EXPEDITED**MONTGOMERY COUNTY HISTORIC PRESERVATION COMMISSION**
STAFF REPORT

Address: 4015 Rosemary Street, Chevy Chase **Meeting Date:** 7/28/10

Resource: *Master Plan* Site #35/127
Chevy Chase Elementary School **Public Notice:** 7/7/10

PROPOSAL: Installation of dumpster enclosure and fence gate

5 DUMPSTER ENCLOSURE - FRONT ELEVATION
SCALE: 3/8" = 1'-0"

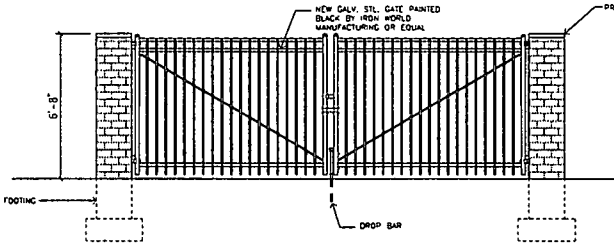
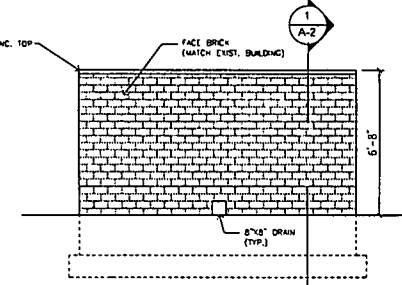
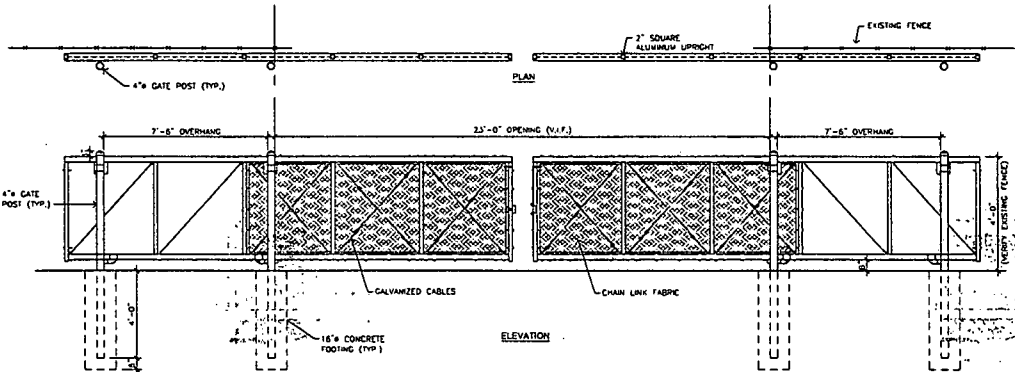
- 1.) The gate of the enclosure will be a solid wood board-on-board fencing material, not open pickets, to screen the dumpsters.
- 2.) The applicants will work with the Town of Chevy Chase's arborist to determine the optimal location for the enclosure and will implement tree protection measures during construction; any change in location to be reviewed and approved at the staff level.

2 PROPOSED SITE PLAN
A-1 SCALE: 1/64" = 1'-0"

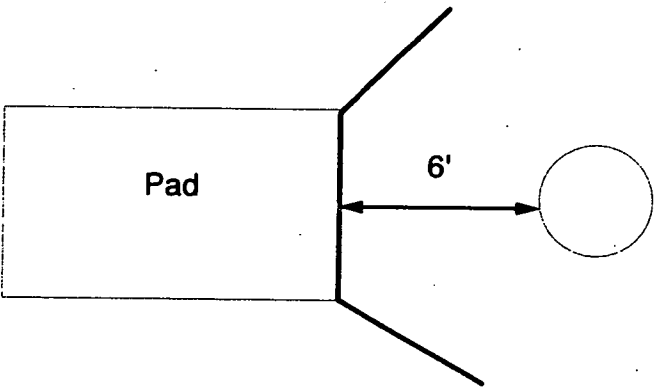
5) the site plan drawing and picture 2 are inconsistent as to where the driveway gate the picture 2 does not picture the dumpster area and takes a snap of the driveway entrance itself--stating the driveway gate will be at the driveway entrance appearing to go north to south--several

yards closer to Hillcrest street than where the current relatively new gate is. The site plan has the only gate going east to west in front of the dumpster only, and not impacting access to the driveway itself.

If the driveway gate is located where picture 2 depicts, there is **currently a gate that locks in the location where they wish to put a sliding chain link fence, only closer to the playground.** It was put in maybe five years ago? It is a freestanding unsightly gate that doesn't connect to a fence, but it achieves an MCPS' safety objective of barring cars from entering the blacktop to drive or park in the rear on the playground at times other than school events is achieved already. (The playground is used for parking for school and rental events.) The enclosed chain link fence' only function, then, is to ensure non-access by the public to the playground through the west end of the playground after school and weekends. Despite the current locking gate, people can still enter, and can bring in their bikes and trikes. I remember when the current janitor tried to lock their new chain link gate on the north side of the property and kept it locked through the evenings and weekends. It hurt the PTA that time because they had a major outdoor carnival and couldn't unload there. It was also a safety hazard during the day, so that lock came off thank goodness.

Third, a significant important reason not to fence off with a black chain link fence and sliding gate east to west in front of MCPS' proposed dumpster area is a large wide open swatch to the hillside abutting Hillcrest near the corner, and then going up the length of Beechwood. town children play on this hill, and up this green space, especially the very young playing hide and go seek. It is one of the few raw unlandscaped play places in Town. People also regularly walk (and pick up after) dogs in this green space. There is no reason for the school to close off access with a building structure and fence. Moreover, kids' balls go over the fence at recess and in day care and staff or children go get them from both east and west ends.

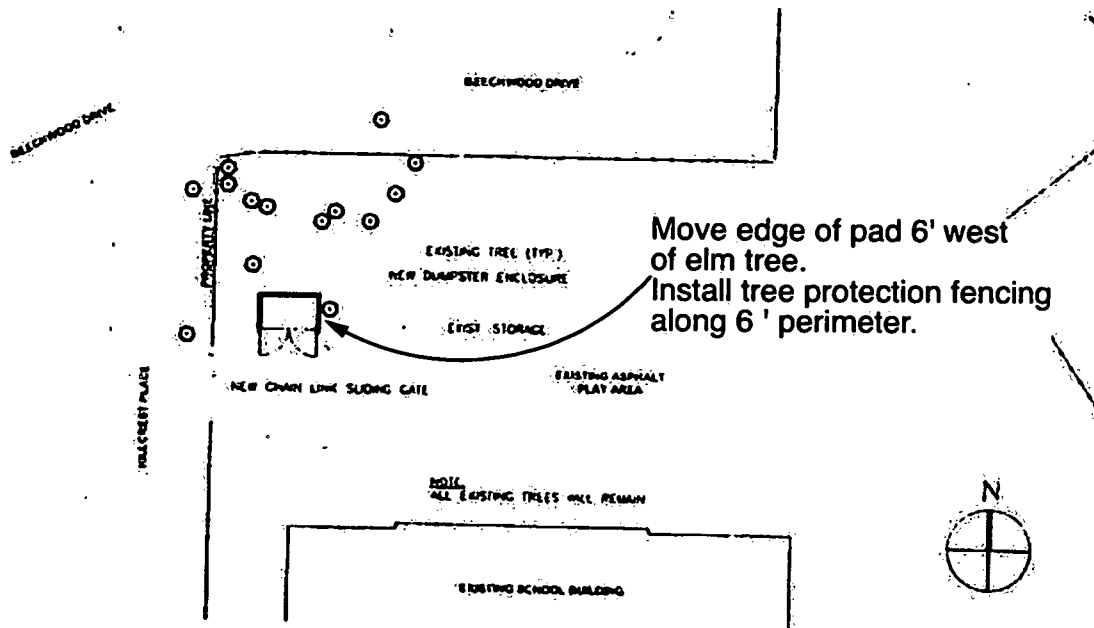
Move edge of pad 6' west of elm tree.
Install tree protection fencing along 6' perimeter.

2. PROPOSED SITE PLAN
A-1 SCALE: 1/64" = 1'-0"

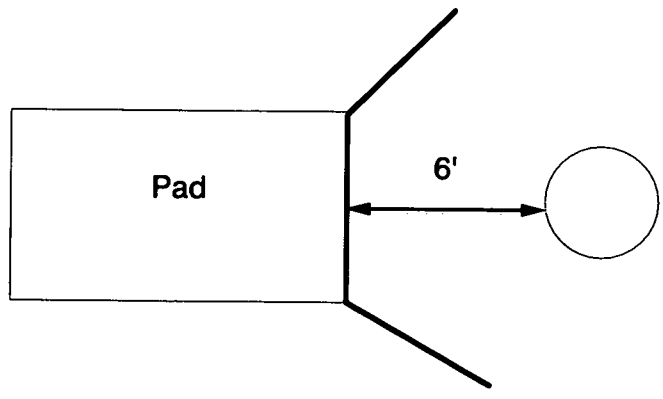
5) the site plan drawing and picture 2 are inconsistent as to where the driveway gate the picture 2 does not picture the dumpster area and takes a snap of the driveway entrance itself--stating the driveway gate will be at the driveway entrance appearing to go north to south--several

yards closer to Hillcrest street than where the current relatively new gate is. The site plan has the only gate going east to west in front of the dumpster only, and not impacting access to the driveway itself.
